Calaveras County Water District
Ebbetts Pass Water System
Reach 3A Pipeline Replacement Project

ADDENDUM No. 3

Date Issued: December 29, 2015

PRV 86 CONNECTION

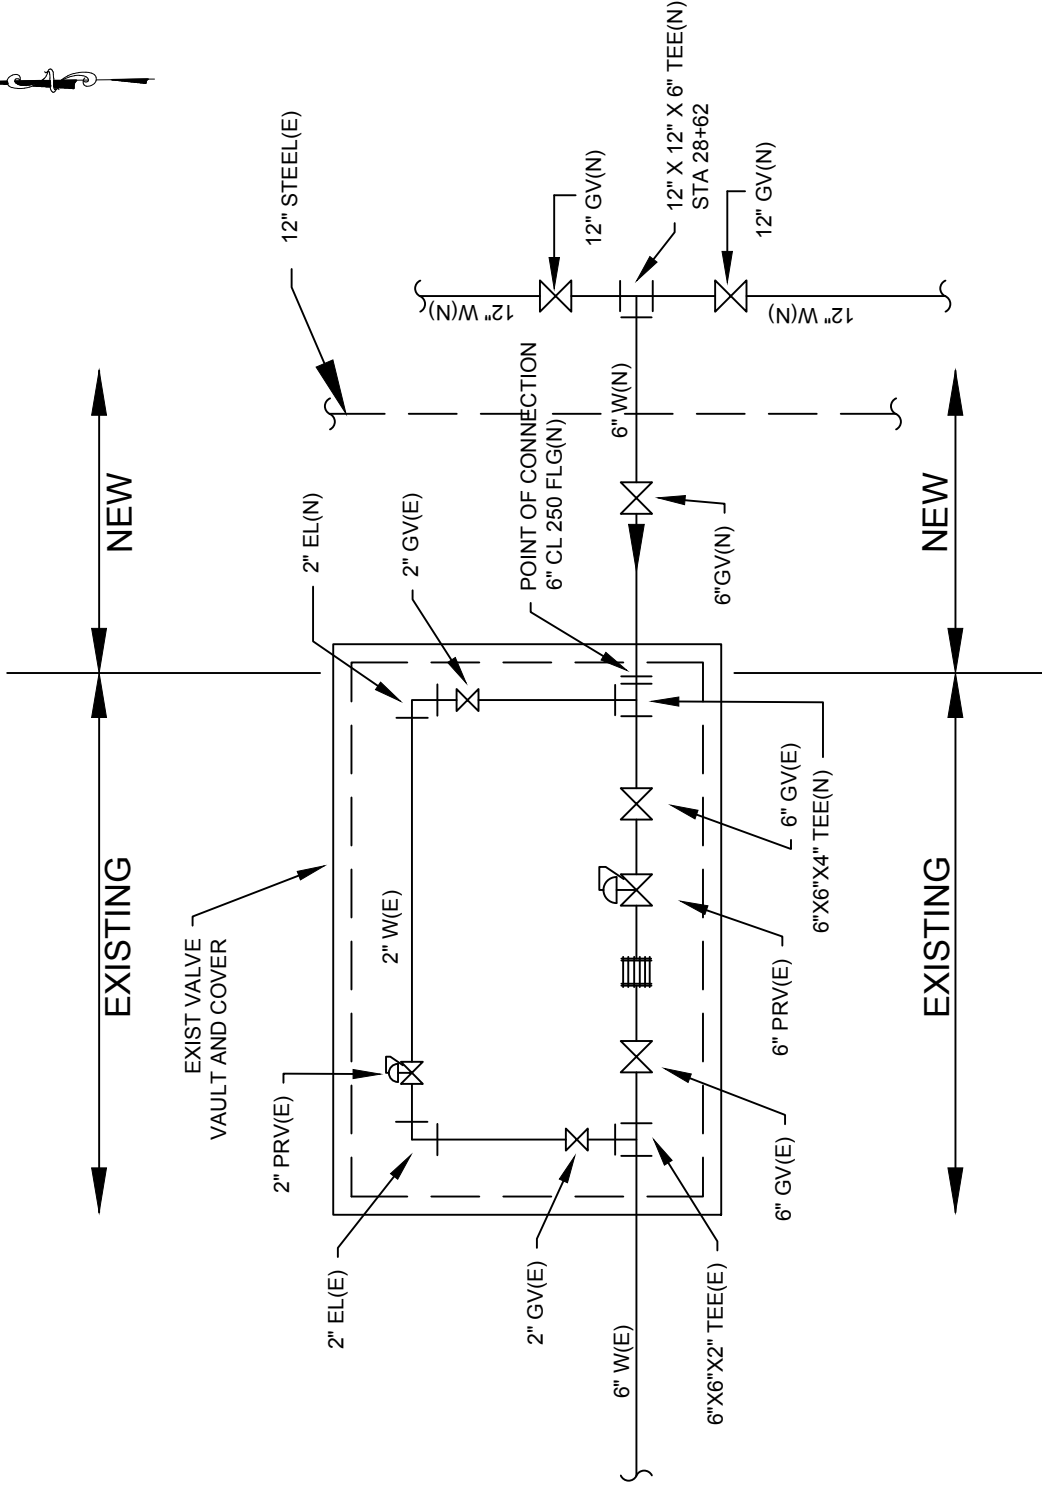
1. Drawing G-004: The work “Meadowmont Branch Line” is not included in contract. Delete Note 26 reference to Wetlands 2 and 3, and delete Note 27 reference to Stream C.
2. Drawing C-1: Tap saddle/tap location for 2” service for Cal-Fire has changed. Tap will be made on fire hydrant lateral just downstream of existing PRV26 resulting in first 20’ of trench for service turning south; otherwise, trench follows same uphill route to existing meter box.
3. Drawings C-1, C-5, C-23 & C-33: Do not demolish existing pressure regulating stations PRV26 (STA13+98), PRV86 (STA28+62), PRV90 (STA 110+83) or PRV55 (STA 156+98); these stations to be reused and reconnected to new 12” main. Delete Details 26R and 86R on Sheet C-301 and Detail 55R on Sheet C-303; use attached revised details for PRV26, PRV86 and PRV55 and PRV90.

21. Drawings C-301 & C-303: Delete/replace Detail 26R with revised Detail 26; delete/replace Detail 86R with revise Detail 86; delete/replace Detail 28R with revised Detail 28R.

| PRV 55 CONNECTION | | |

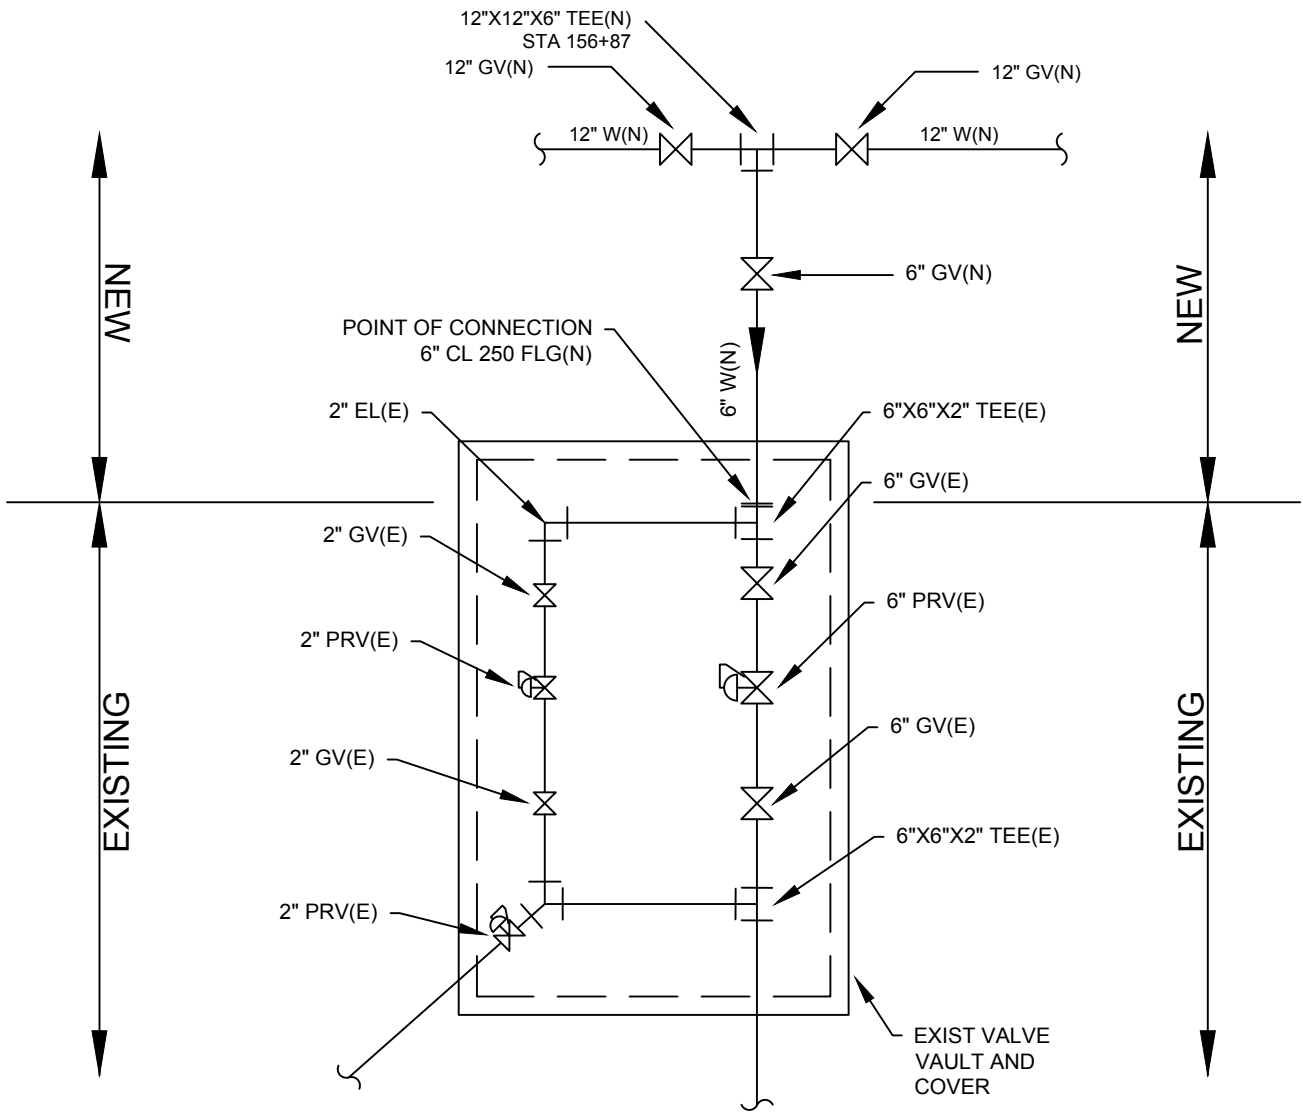
22. Drawing C-303: Delete/replace Detail 55R with Detail 55. On PRV93R detail, delete 6"x6"x2" tee and 2" service, provide two 1" water services shown correctly on Sheet C-35.

| DRAWN BY: CCWD STAFF | SCALE: NONE | CCWD DRAWING SHEETS C-23 (STA 110+83) |

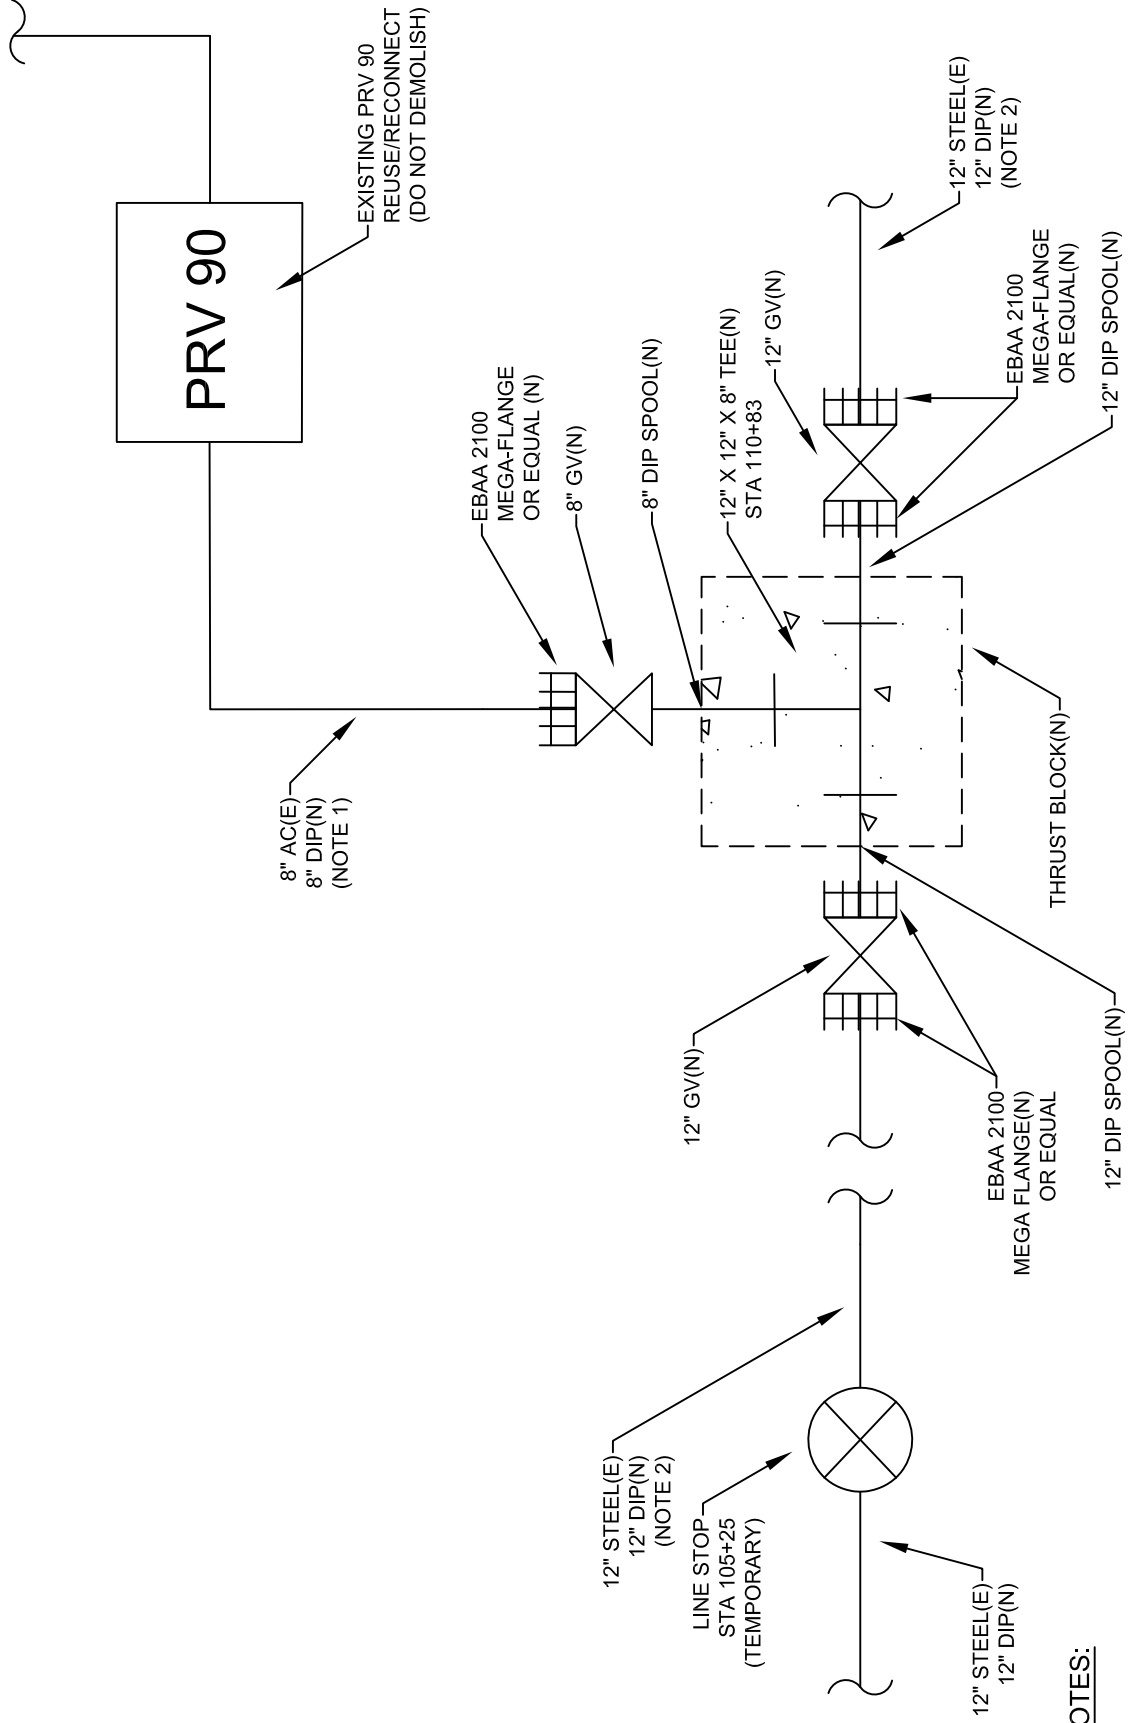
12. Drawing C-22 (Grid A2): As described in revised Section 02110, Sequence of Work, Paragraph A.13, provide Line Stop at approximately STA 105+25.
13. Drawing C-23 (Grid A3): Add connection detail for PRV90 attached. Also, replace 1" water service at STA 111+00; connect to new 6" water main in Fir St.

REMOVE AND RECONSTRUCT PRV 38/38R PER SEQUENCE

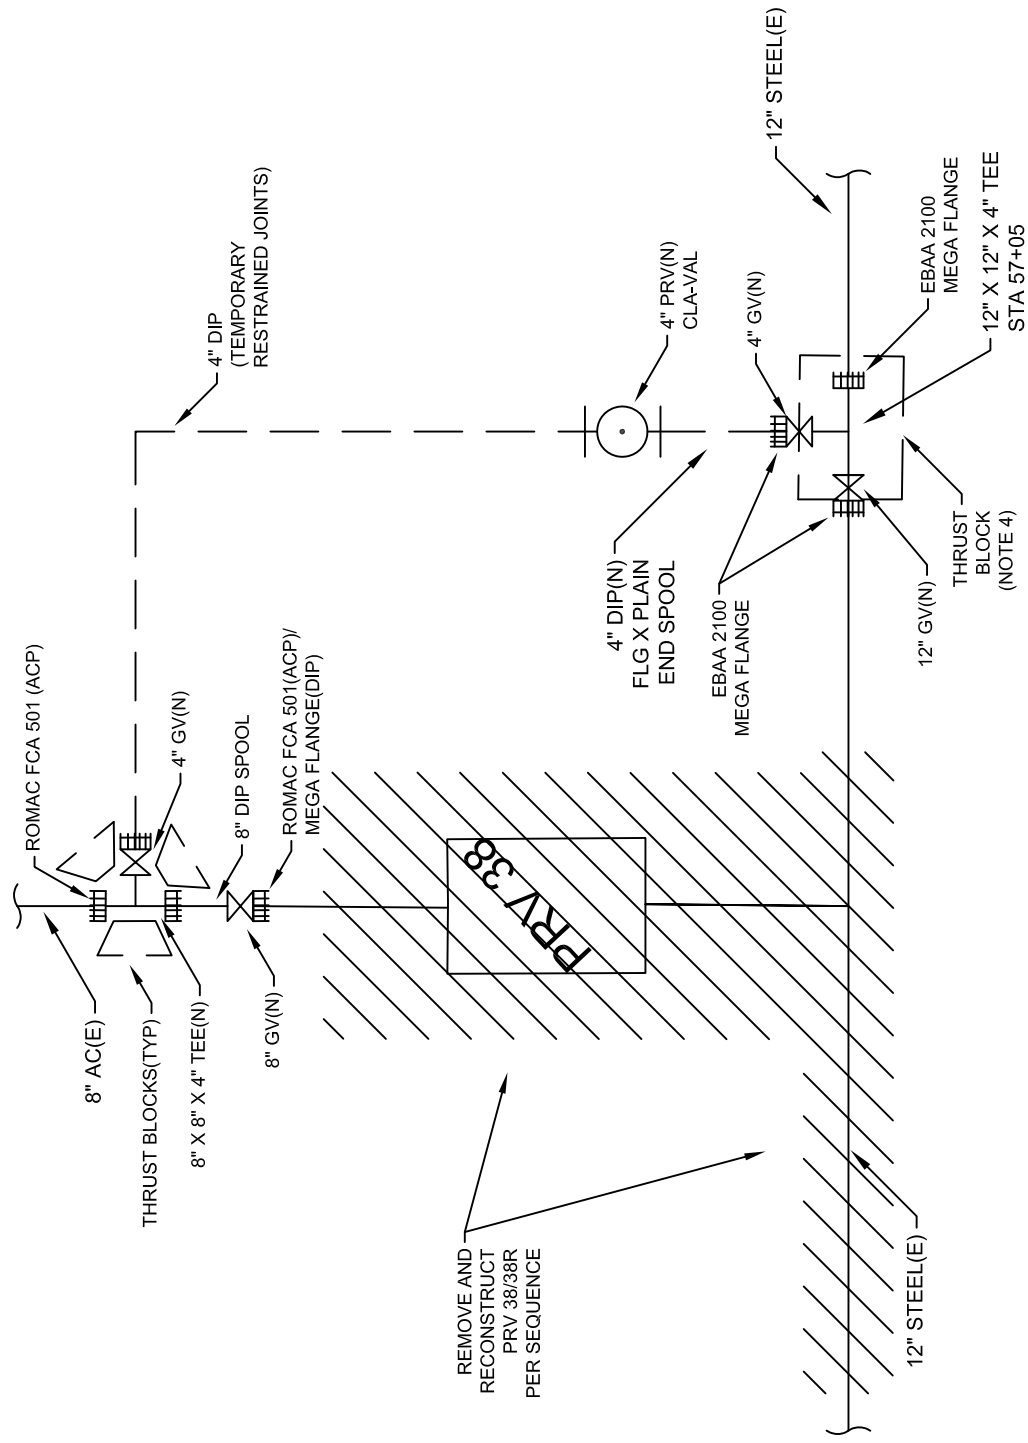
5. Drawing C-11 (Grid A3 & B3): On exiting 12" steel main at STA 57+05, provide temporary bypass as shown on attached Detail/PRV38 Temporary Bypass Valves/Piping.

| CCWD DRAWING NAME SHEET C-17 | |

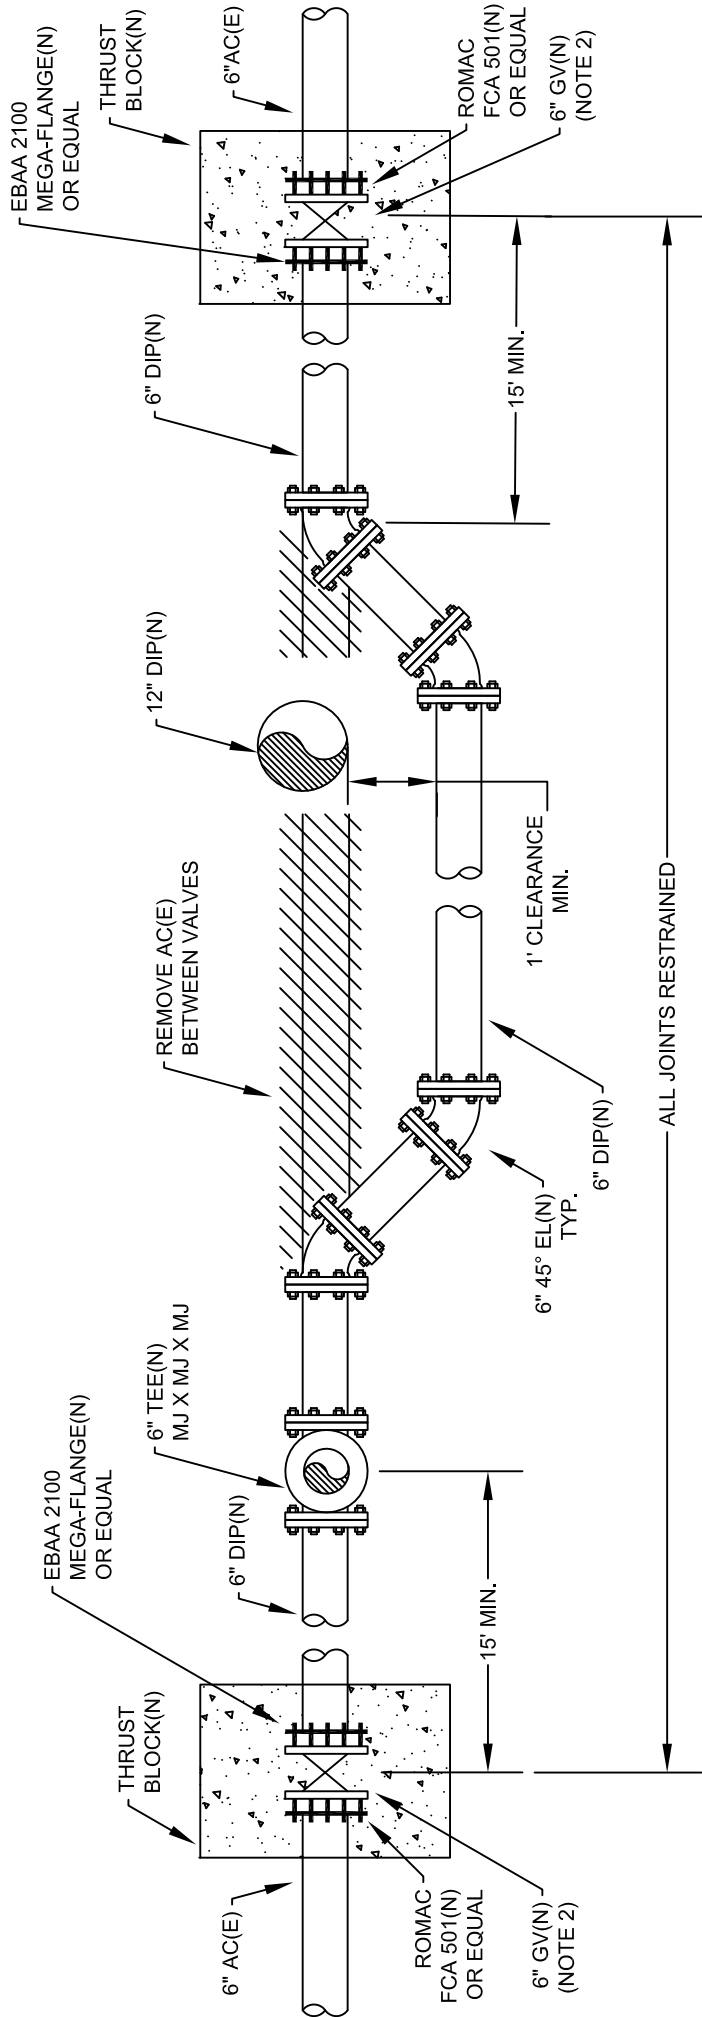
7. Drawing C-17 (Grid B4): Add attached detail for Pine Drive 6" water main relocation; remove and replace water main downstream of PRV45R to its tie-in at Pine St.

REVISED PROFILE STA 88+40 TO 89+20

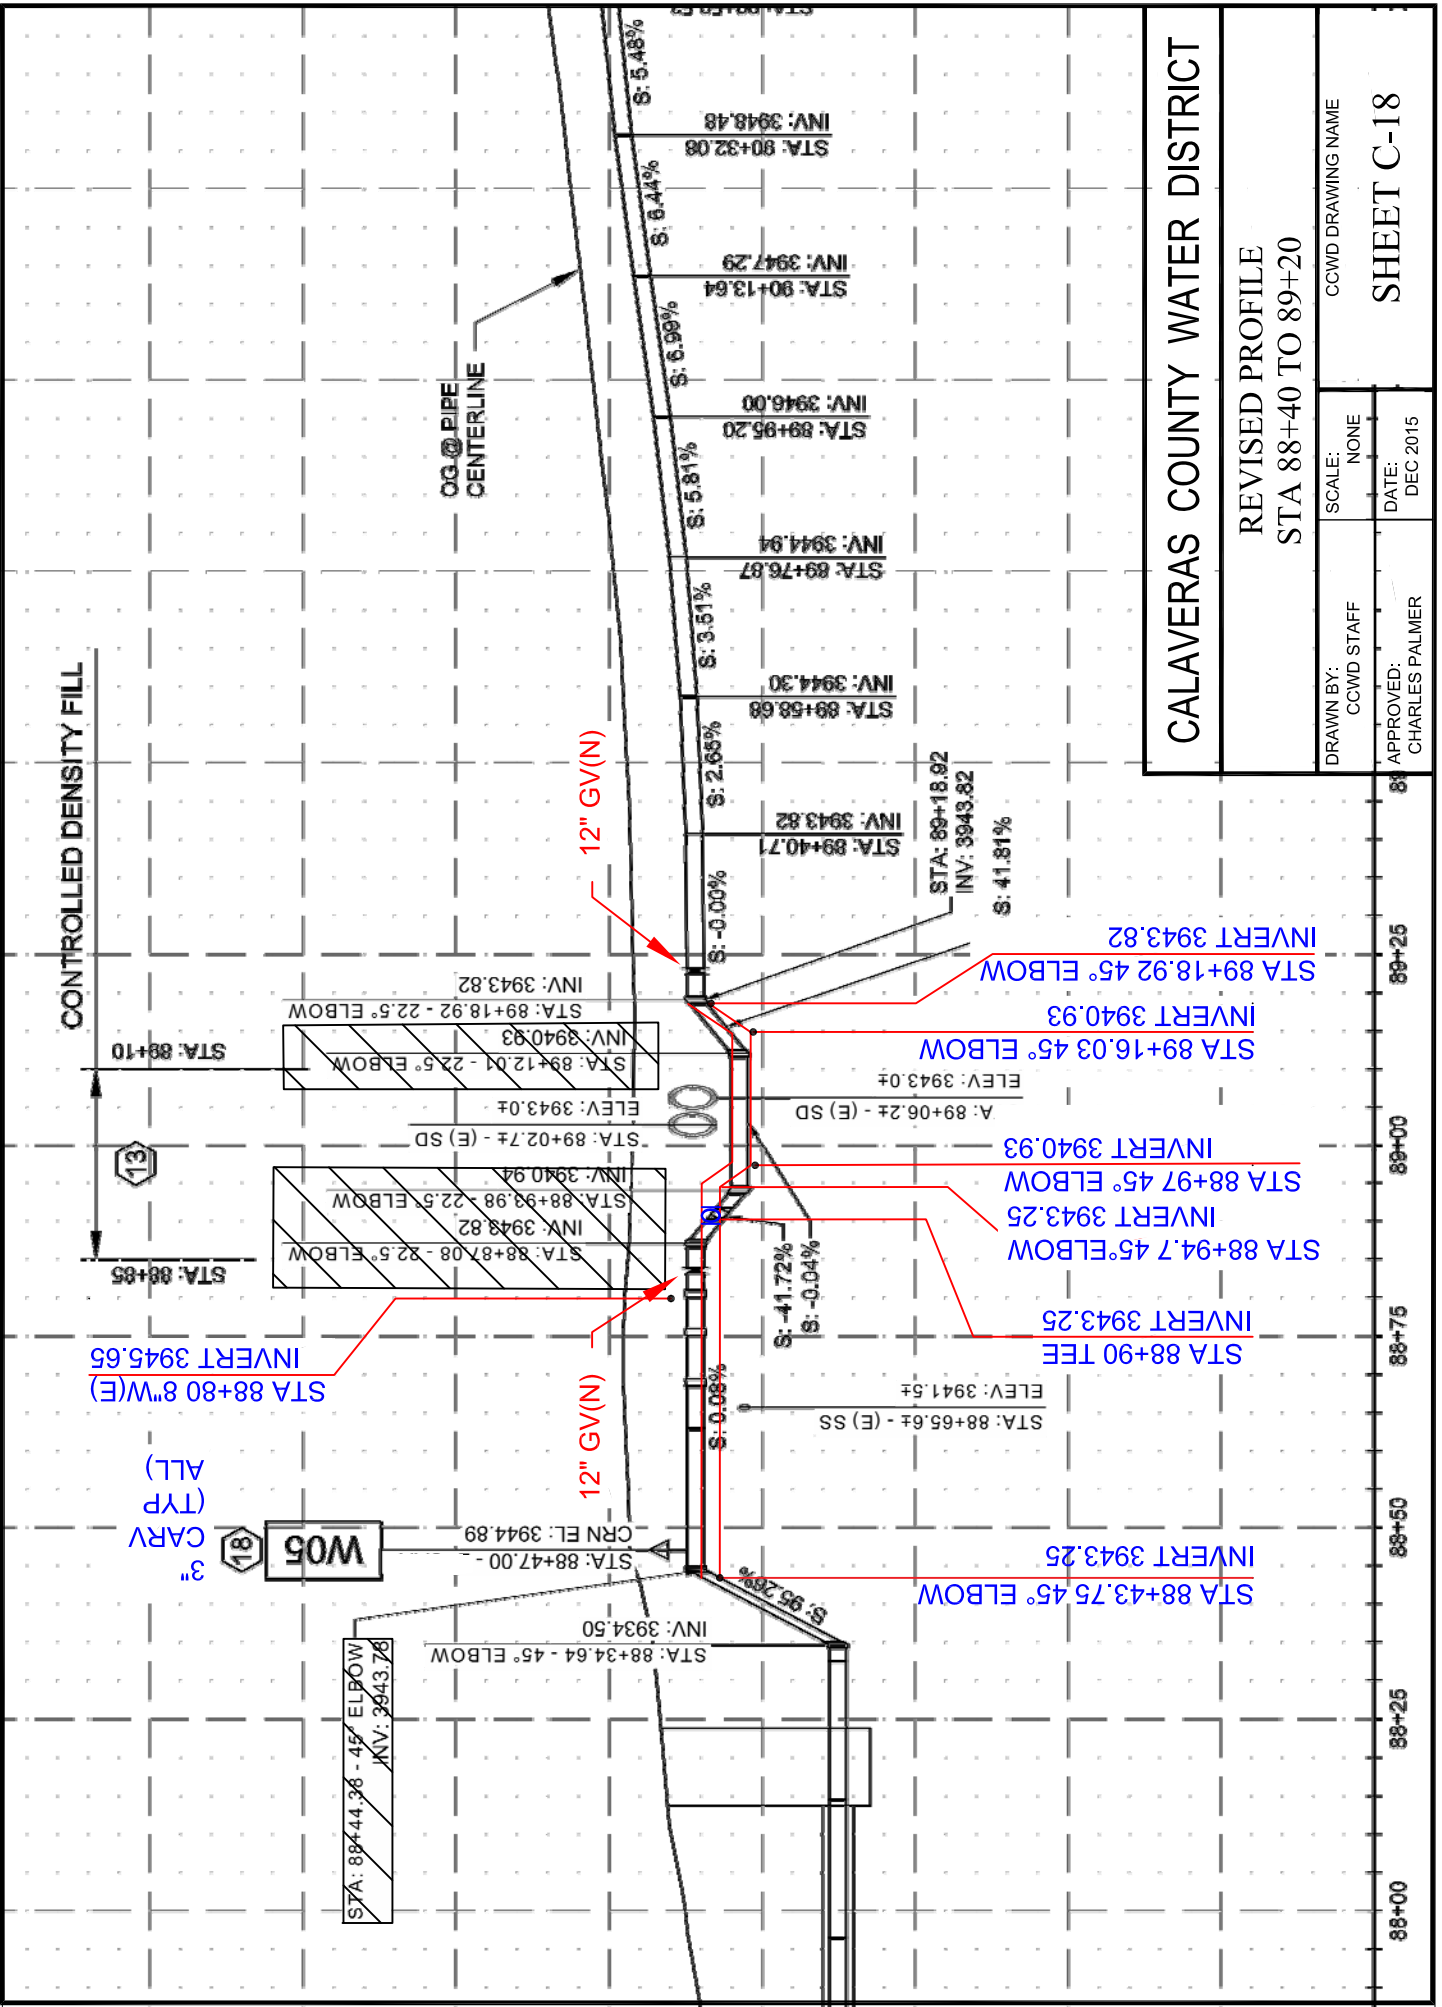
8. Drawing C-18 (Grid C3 & D3): Existing 8" C900 PVC water main at approximately STA 88+80 is in conflict with new 12" DIP main; see attached/revise profile.
